Revenue Mine: TR-01 Submittal

This letter and associated attachments is in response to the Silver Star Resources Revenue Mine Technical Revision-01 Adequacy Review Letter dated October 31, 2013.

APPENDIX 6 – STORMWATER CALCULATIONS AND DESIGNS

APPENDIX 12 REVENUE MINE – MINE WATER HANDLING SYSTEM

Weep Lines Trench Cross-Section

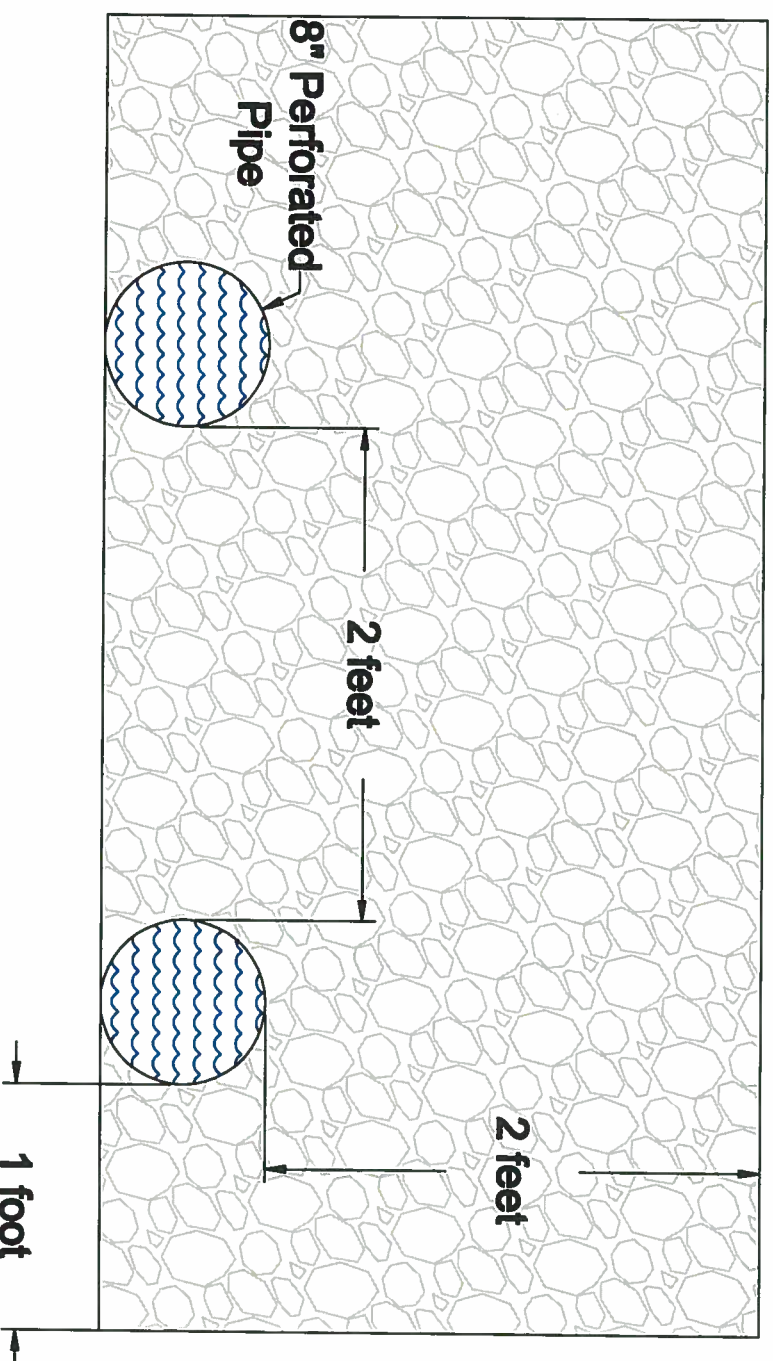
5. Water discharge pipes no. 1 and 2 (aka the "weep lines") described in Appendix 12 will be buried in the old waste rock, in a location that extends along the toe of the natural slope south of the former location of the old mine water pond. The map shows them to be in close proximity to each other. Please state whether there will be any horizontal or vertical distance between them, and/or whether they will be buried in the same trench.

The weep lines will be spaced 2 feet apart in the same trench. See Map G-13 for a design drawing of the weep line trench cross-section.
